Delegated Report

Householder and Listed Building Consent Applications

Planning Application No: 20260396
20260397

Location: Mill House Hermitage Road Higham Rochester

Proposed

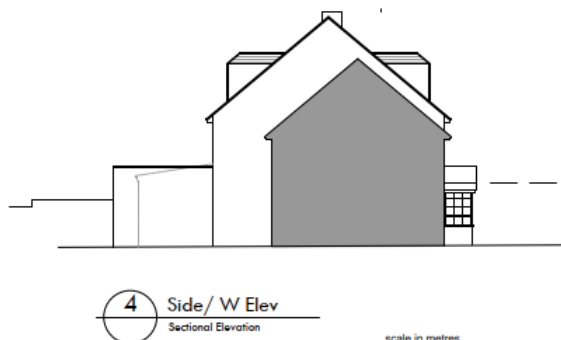
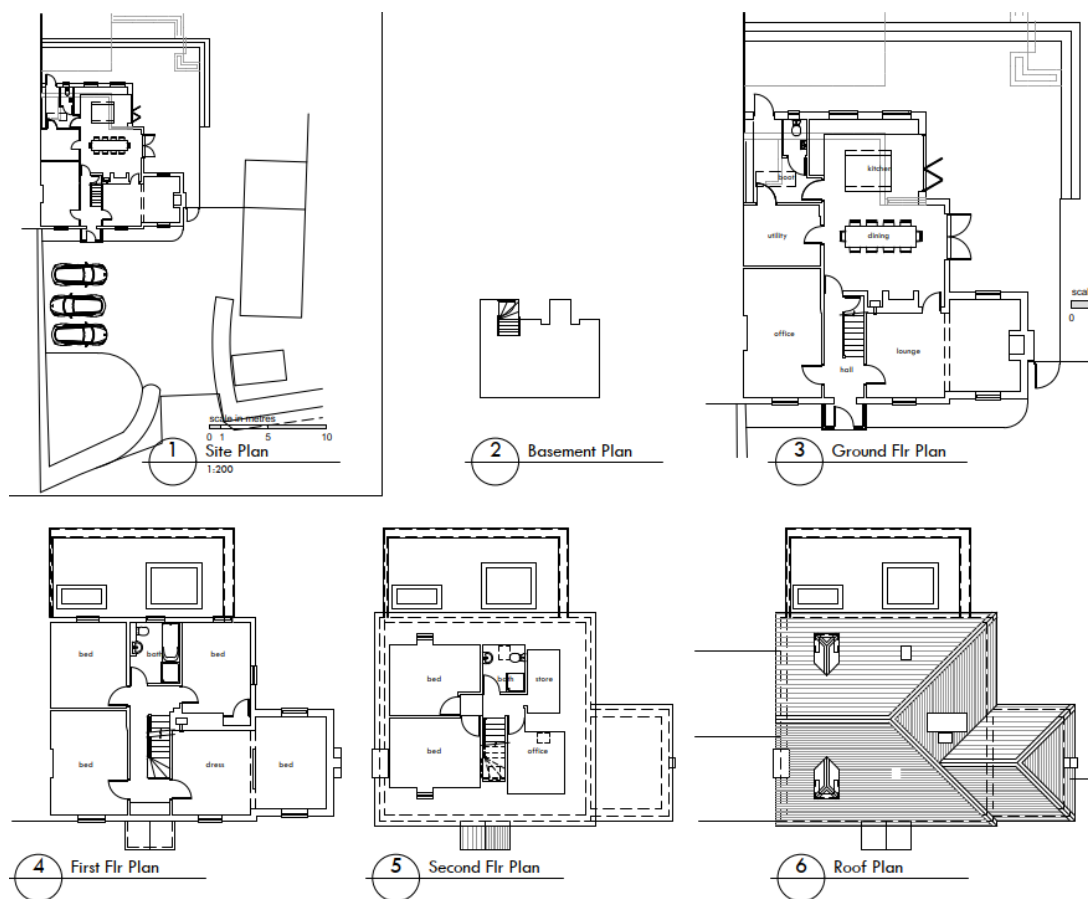
The Conservation Officer in his comments stated *"In addition to the loss of the opening, the width of the proposed extension dominates the Listed Building and causes further harm to its setting and appearance."* It is therefore clear the Conservation Officer made comments on the extension and considered that the width of it would dominate the listed building. What the agent considers to be a marginal amount would extend the extension across even more of the original rear elevation part of the building than is currently the case with the existing sunroom, obscuring even more of the original rear elevation and the Conservation Officer does not support this increased width as they consider that the extension would then dominate the listed building. The existing extension is 6.1m in width with a gap to the original flank wall of 2.79m and the proposed extension would be 7.9m in width with a gap to the original flank wall of 1m.

Furthermore, and it is not mentioned in the previous delegated report, the proposed extension would have a flat roof whereas the existing sunroom has a mono pitched roof. The flat roof, whilst an acceptable roof form for a single storey rear extension on many properties across the Borough would not be acceptable for a listed building where the design quality would be expected to be of even greater than normal. In any case the proposed design would not be in keeping with the age or character of the building. The proposed flat roof would not be in keeping with the roof form of the host building and the extension would appear as a standard box-like structure on the back of this listed building, which would be completely out of keeping for this listed building dating from 1760. On a listed building the whole building is listed and any extension should protect its architectural and historic interest regardless of which elevation it would be on and this proposed extension would clearly not achieve this. It is not a case that it is at the rear and so design doesn't matter anymore. The window proportions are out of keeping with the existing windows on the rear elevation and the door appears as a standard door, again not in keeping.

There is then also the matter of the kitchen window which would be removed due to the proposed extension. It is clear from his comments that the Conservation Officer acknowledges that the original single window opening has been altered to a double window opening but he states that the side of what would have been the original window opening (i.e. the eastern side) lines through with the first floor window above

and he is stating that the proposed extension would lose that completely, given that the whole of the window opening would be removed. That would therefore remove the last vestiges and reference point of what was the original ground floor window opening which is what the Conservation Officer objects to.

In summary, the proposed extension by virtue of its scale and design and that it would result in the loss of the remaining part of the original window opening in the rear elevation and destroy the correlation with the first floor window above, would be harmful to the architectural and historic interest of this grade II listed building. As such the proposal would fail to meet the requirements of Sections 16 (2) and 66(1) of the Planning (Listed Buildings and Conservation Areas) Act 1990 and would be contrary to Policies CS19 and CS20 (LPCS), saved Policy TC2 (LPFR) and sections 12 and 16 of the NPPF (2024). The proposal has therefore not addressed ground of refusal no. 2 of planning application ref. 20250602 and the ground of refusal of listed building consent application ref. 20250603.

Fig.1. Existing drawing at time of 1994 application

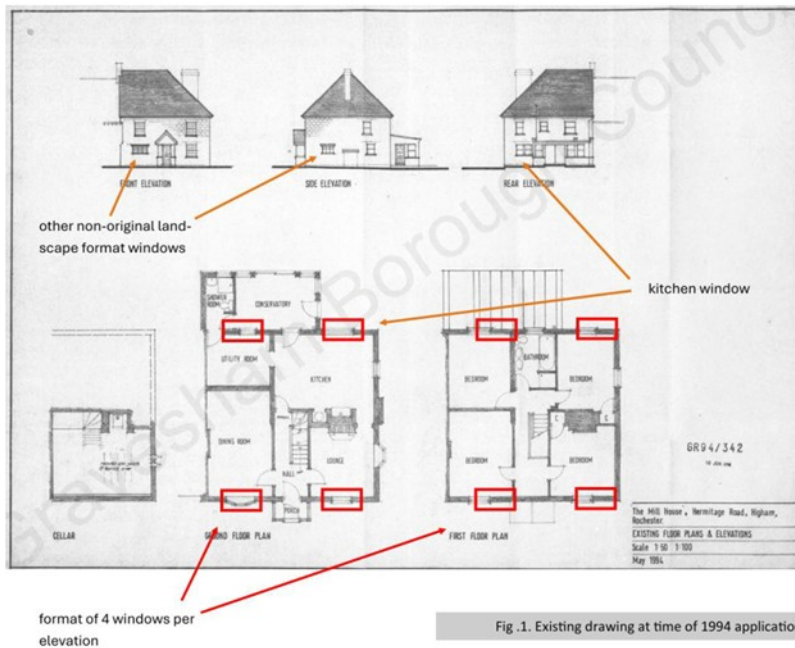
- The drawing also shows that the format of windows to both the front and rear elevation was 4 windows (2 on each floor) set symmetrically to each corner of the front and rear elevation with a central door and a central window over on the first floor (to the rear elevation only);

- The cill height of these original windows would be around 770 – 780 mm above floor level (at ground floor) which is evident to all ground floor windows however the cill height of the kitchen windows are higher than this and it is likely that the kitchen window cills were adjusted to allow a fitted kitchen to be installed in the property. It is also likely that at the same time the opening was widened to account for the loss of light created by a shorter window, this is reinforced by the fact that this window is over the kitchen sink and provides views over the garden and therefore the owners likely wanted the window to be enlarged to retain the sense of lighting in the former portrait window. There is no reason to suggest that this window format was original given all of the above;
